# Access Compliance Report

## Public Rights-of-Way

### (Curb Ramps)

Intersection ID: 49932	Main Street: WOBURN_RD	Cross Street: PAXTON_RUN_RD	Location: NW
ADA ID: 285B43EA72FA	Ramp Type: Perp	Initial Pass/Fail: Pass	Overall Compliance: No
		Severity Score: 0

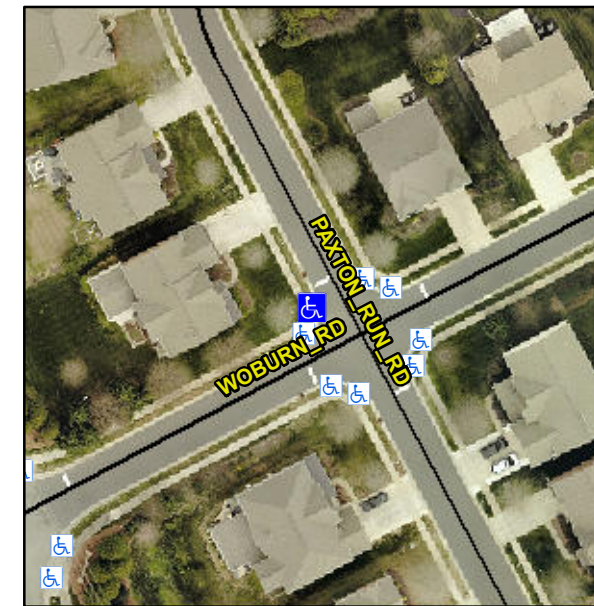
**Not Found, R304.2.2-Perp, R304.3.2-Para, R302.7**

Compliance	Description	Data	Compliance	Description	Data
N/A	Ramp Length (in)	48.0	Yes	Ramp Slope (%)	8.1
Yes	Ramp Width (in)	48.0	Yes	Ramp XSlope (%)	0.6
N/A	Flare Type LT	Sloped	N/A	Flare Type RT	N/A
N/A	Flare Slope LT (%)	4.9	Yes	Flare Slope RT (%)	4.7
N/A	Flare Traversable LT?	Yes	N/A	Flare Traversable RT?	Yes
Yes	Landing Length (in)	48.0	Yes	DWS Provided?	Yes
Yes	Landing Width (in)	48.0	Yes	DWS Contrast?	Yes
No	Landing Slope (%)	3.5	Yes	DWS Length (in)	24.5
Yes	Landing X Slope (%)	1.4	Yes	DWS Full Width?	Yes
N/A	Landing Curb? (Y/N)	No	Yes	DWS Offset (in)	2.0
N/A	Shared Landing?	No			
No	Gutter Ponding?	Yes	Yes	Gutter Slope (%)	1.5
Yes	Gutter Lip Ht (in)	0.0	Yes	Gutter X Slope (%)	0.1
N/A	Painted X Walk1?	No	N/A	Painted X Walk2?	N/A
	X Walk 1 Direction	To NE		X Walk 2 Direction	N/A
N/A	X Walk 1 Width (in)	N/A	N/A	X Walk 2 Width (in)	N/A
	X Walk 1 Slope (%)	0.2		X Walk 2 Slope (%)	N/A
	X Walk 1 X Slope (%)	0.4		X Walk 2 X Slope (%)	N/A

N/A	Ramp inside XWalk1?	N/A	N/A	Ramp inside XWalk2?	N/A
	Road Slope (%)	N/A	N/A	Clear Space?	Yes
	Road X Slope (%)	N/A	N/A	Clear Space to XWalk (in)	N/A
Yes	Any Obstructions?	No	Yes	Storm Grate/Utility Hazard?	No
	Obstruction Type			Storm Grate/Utility Type	
		N/A			N/A
			Yes	Surface Condition? (G/P)	Good

**Remove & Replace Entire Ramp.**
